Attorney's Docket No.: 07326-002003

Amendments to the Drawings:

Page 1 of 2
MODULAR COMPUTER SYSTEM
Scott Lochner et al.
09/994,520
07326-002003
ANNOTATED SHEET

FIG. 3

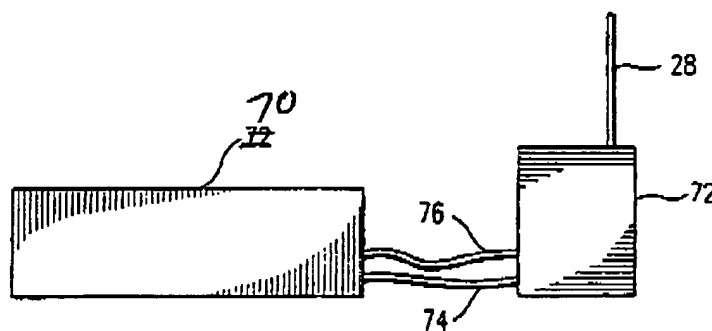
Figure 3 has been amended to properly recite the unit 70.

The drawings stand objected to under Rule 1.83(a). The video generation unit, and a notation that the video represents "n bits", has been added to Figure 2. Figure 3 has been amended to properly show the "unit 70".

FIG. 2

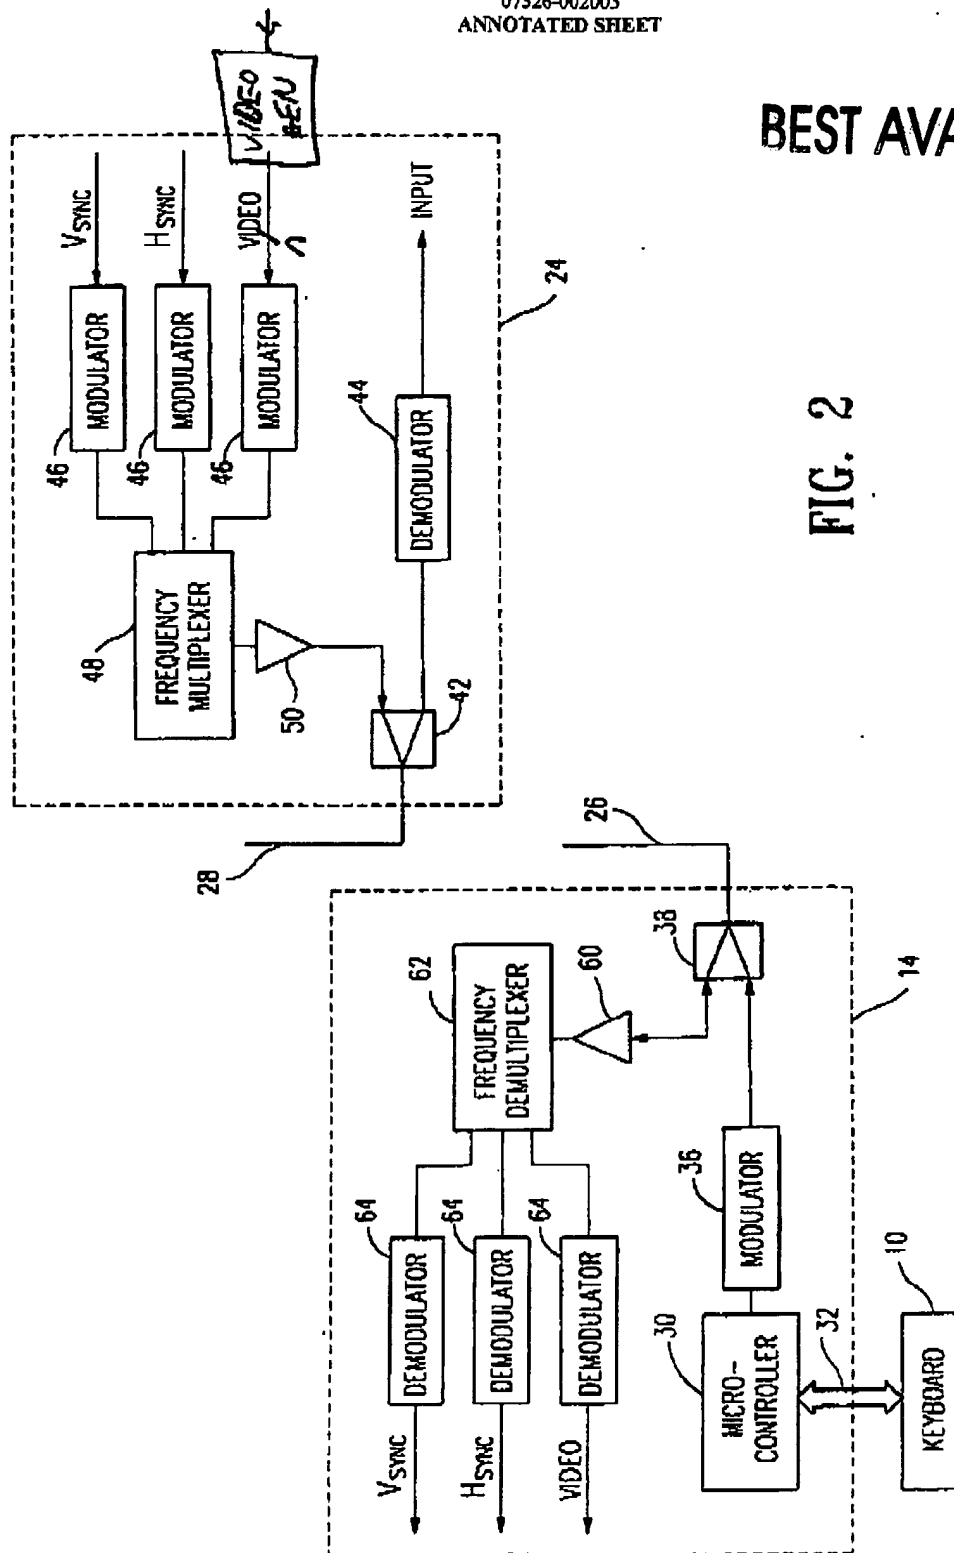
Figure 2 has been amended to add the video generation unit, and a notation that the video represents "n bits".
